## Foundation Design Peer Review

# Darwin Green, BDW1

Job No: P23-635  
Doc ref: BDW1-SIM-XX-XX-RP-S-0001-P01

**Project Name:** Darwin Green BDW1 – Foundation Design Peer Review

**TYPICAL FOUNDATION SECTION**

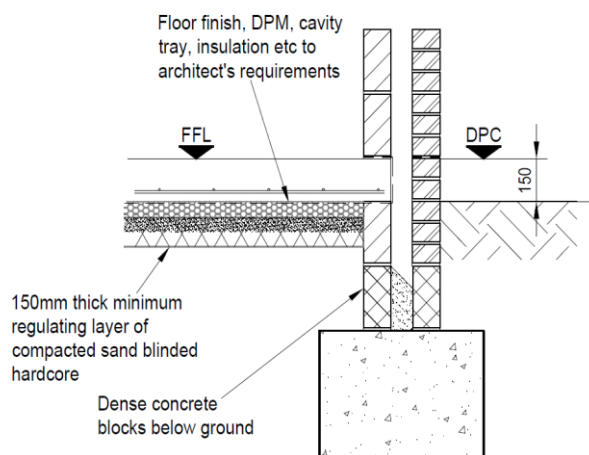
The substructure design of BDW1 was carried out by Rolton Group which adopted a suspended precast beam and block ground floor system as described above and shown in Figure 1 below.

The adopted detail for BDW1 minimises the risk of the underlying clays from heaving as the ground is free to swell within the substructure void provided.
